Project Name: Gunther Volvo

Request: Class III Site Plan Modification

SITE PLAN REVIEW AND APPEARANCE BOARD

Meeting: February 13, 2019 | File No.: 2019-074-SPM-SPR-CL3 | Application Type: Gunther Volvo

DIMENSION SITE PLAN

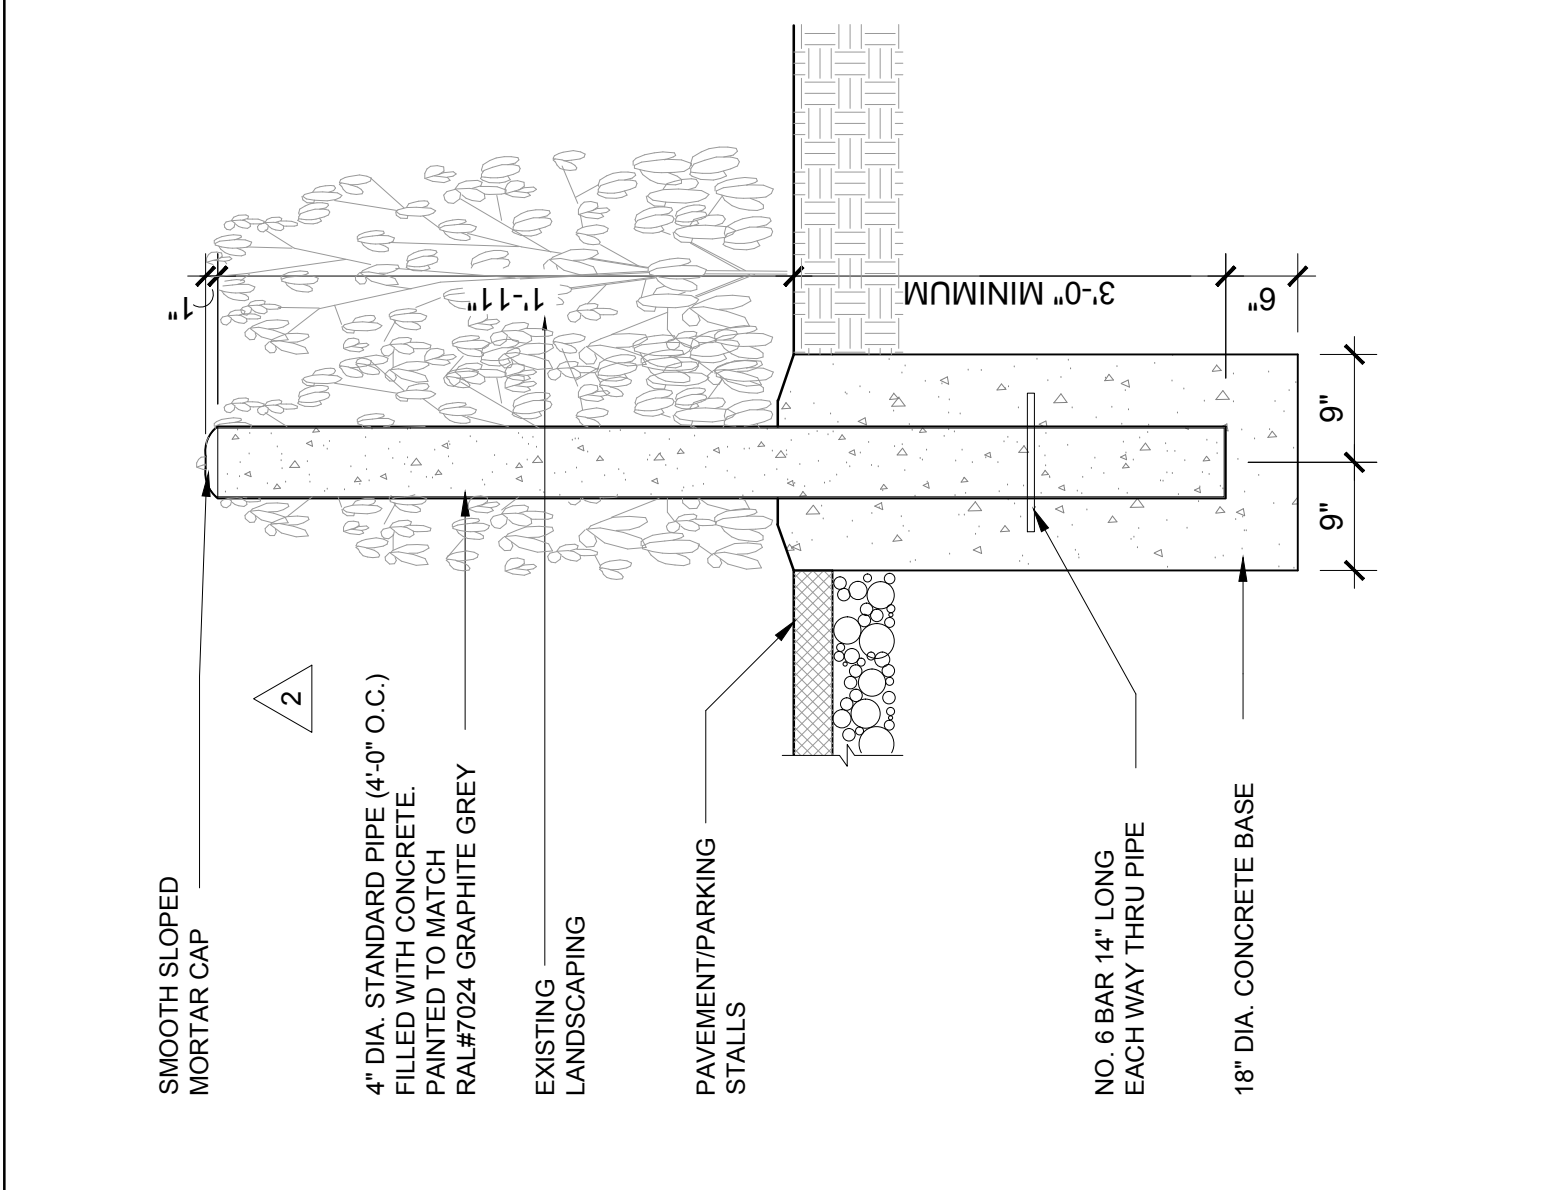
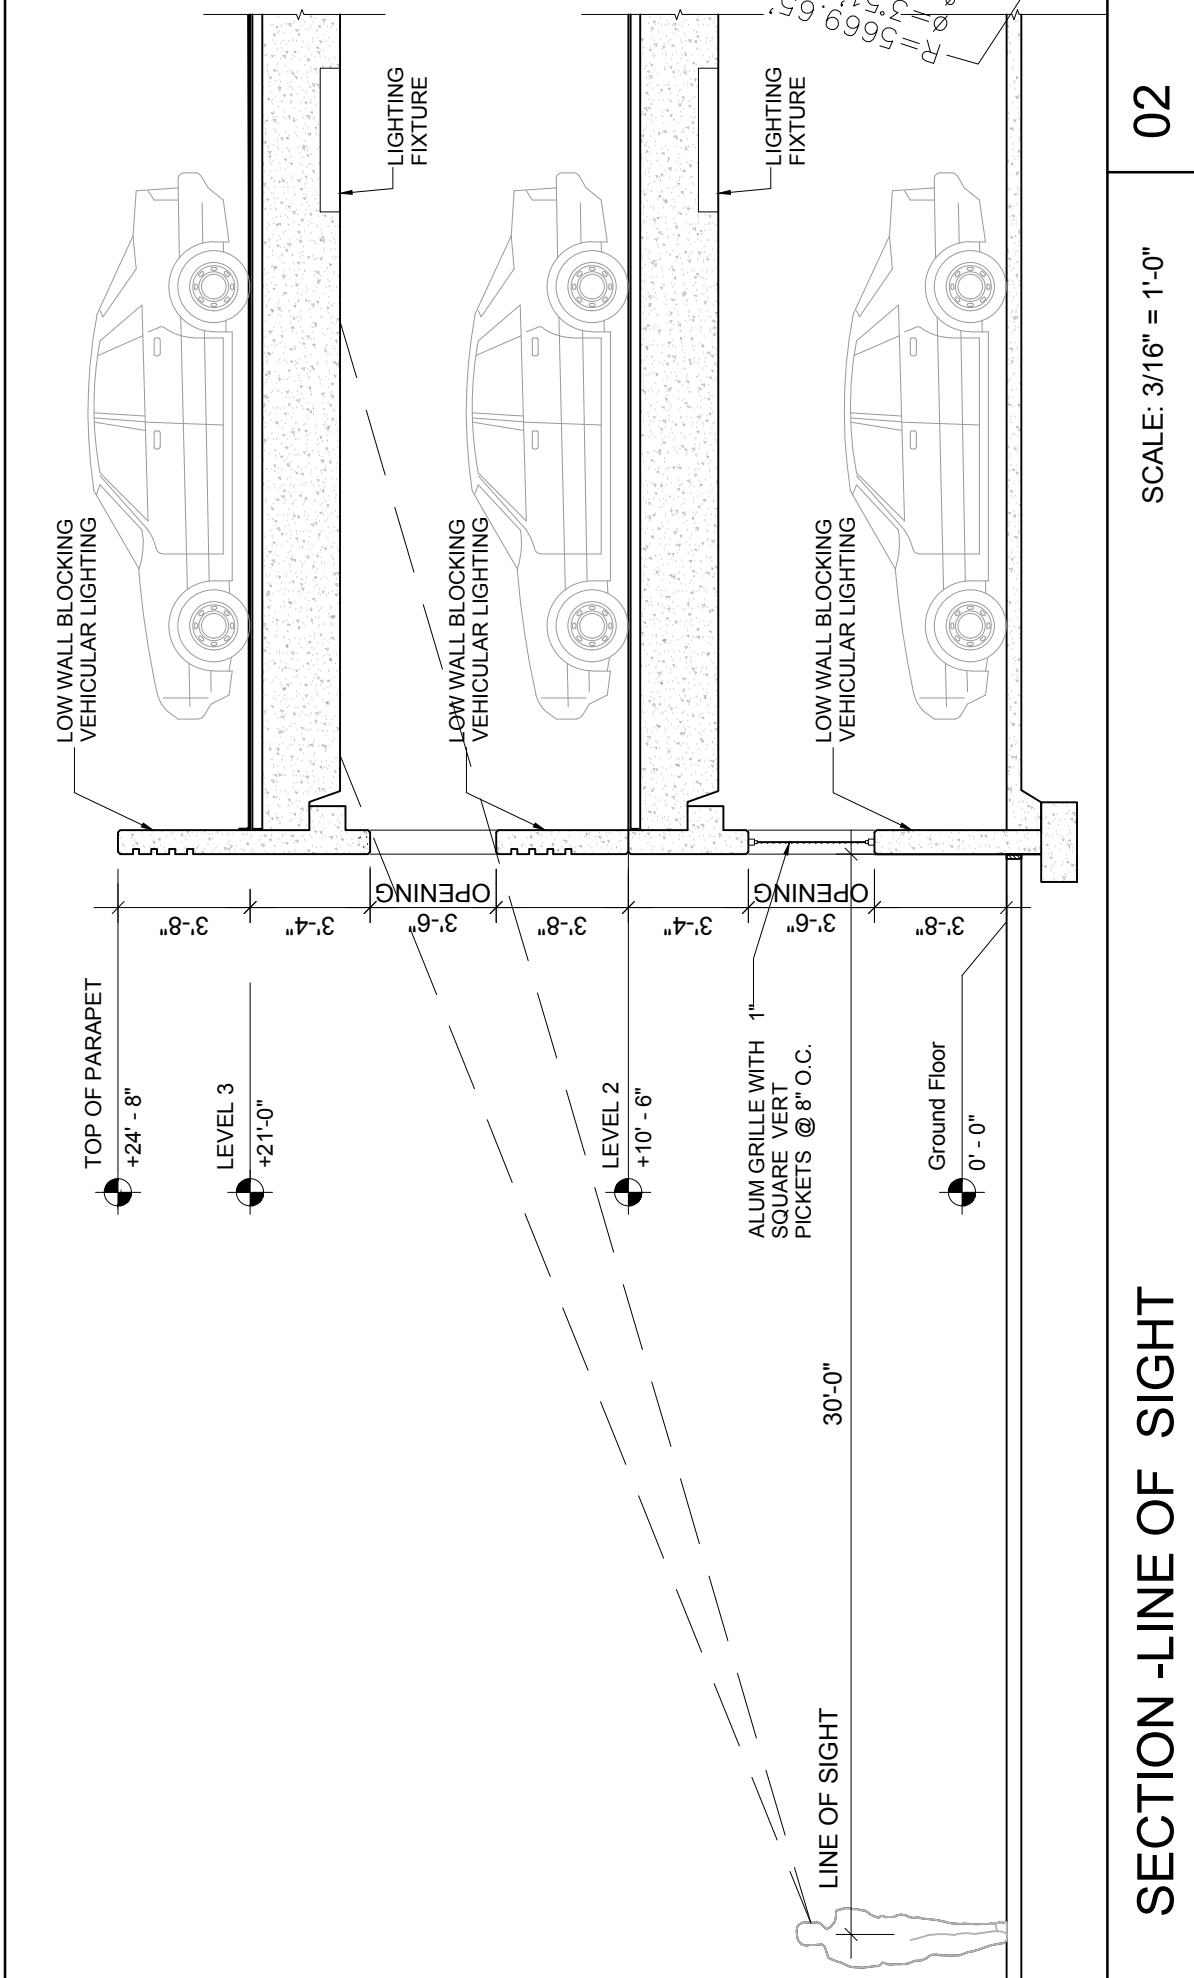
1. A reduction of the width of a walkway in front of the showroom on the west side of the property from 8' to 5',
2. A reduction of the width of a driveway in the front of the building from 26' to 24' feet.
3. A minor reduction and reconfiguration of the hardscape area west of the vehicular display area.
4. An elimination of three parking stalls.
5. Minor landscape modifications and additions.

The action before the Board is for the approval of a Class III Site Plan Modification application associated with the shifting of the building by 6'-10" to the west, and minor site plan reconfiguration for the Gunther Volvo project pursuant to LDR Section 2.4.5 (G)(1)(c), including the following:

1. Provide revised engineering plans with the correct hatch patterns prior to site plan certification.
2. Indicated fire main size on the plans prior to site plan certification

LANDSCAPE
PLAN

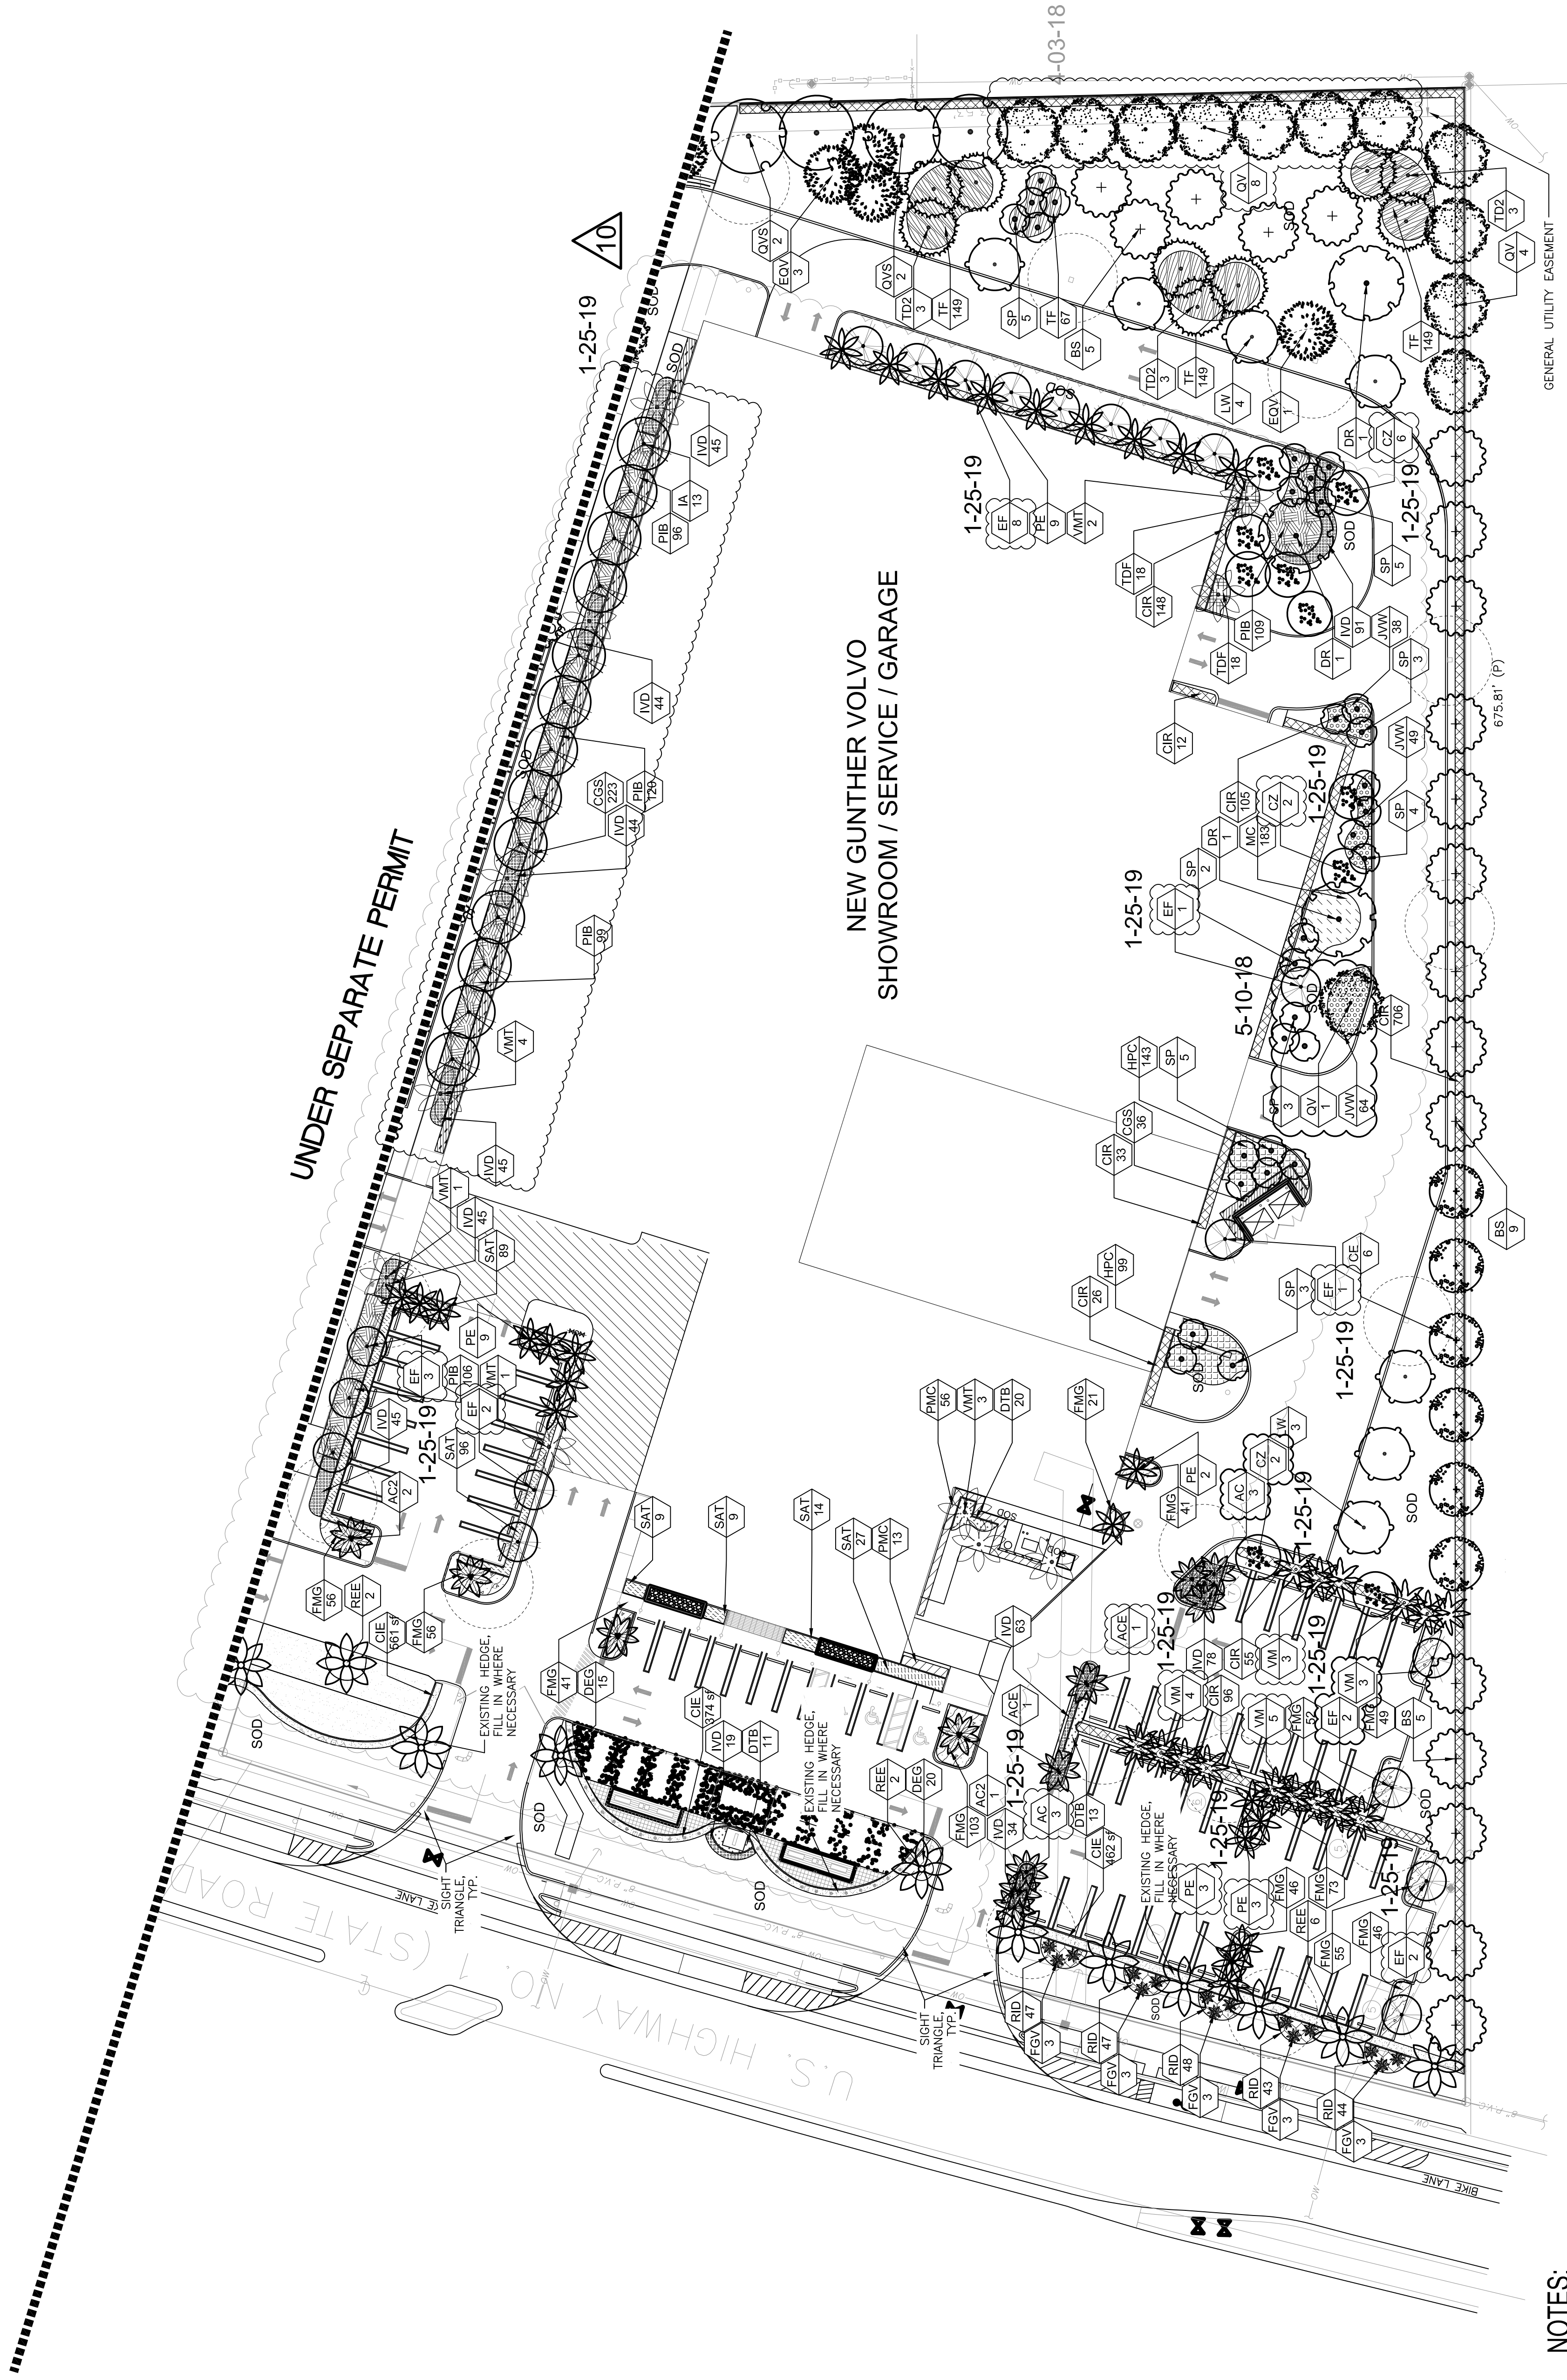
- ✓ Pursuant to LDR section 4.6.16(C)(1)(a), prior to the issuance of a building permit for a structure or a paving permit, compliance with the requirements of Section 4.6.16 shall be assured through the review and approval of a landscape plan submitted pursuant to Section 2.4.3(C). Revised landscape plans provided have been submitted, evaluated and recommended for approval by the City Senior Landscape Planner. The plans show the same landscape design and quantity of trees and shrubs as what was approved by SPRAB on the previous site plan (2017-009) and permitted #17-00170536. The landscape design includes abundant screening of foliage composed of various shrubs, Silver buttonwood, and Gumbo Limbo trees along the south property line adjacent to the multi-family property and Live Oaks and Gumbo Limbos along the east property line adjacent to the single-family properties. Thus, this requirement has been met.
